Product **UPDATE**

Applications:
Caterpillar® 3500 Series Engines

Part Numbers: 2067030
2082364

**Magnum Diesel
3500 Series
“EUI & MUI”
Cover Seals**

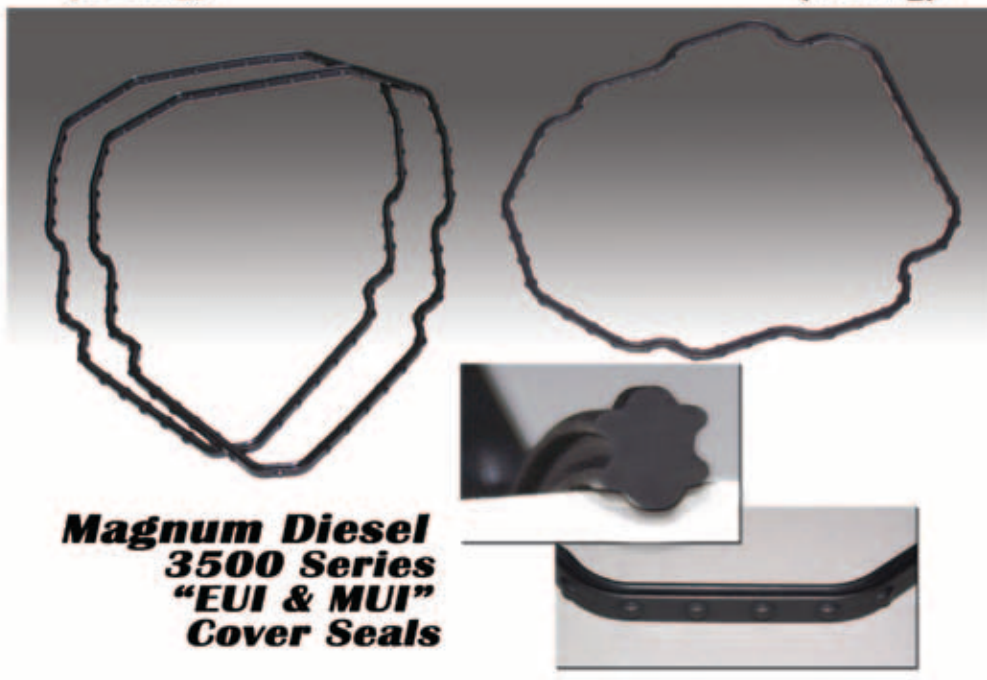
**New Seal Configuration and Material is
Now Available for use on Caterpillar® 3500
MUI and EUI series gas, diesel, marine and equipment engines...**

**The latest seal design features molded index tabs, dual pressure distribution sealing
points on both sealing surfaces. Molded from high quality HNBR compounds, these
new designs provide improved sealing and extended seal life for 3500 series engine
applications over the former O Ring designs.**

Former Part #'s:

**4W1596 Red Silicone
(O Ring)**

**1345958 Black HNBR
(O Ring)**

Former Part #'s:

**2W2072 Red Silicone
(O Ring)**

**1345959 Black HNBR
(O Ring)**

Current #:2067030

Black HNBR Custom Molded Design

Current #:2082364

Black HNBR Custom Molded Design
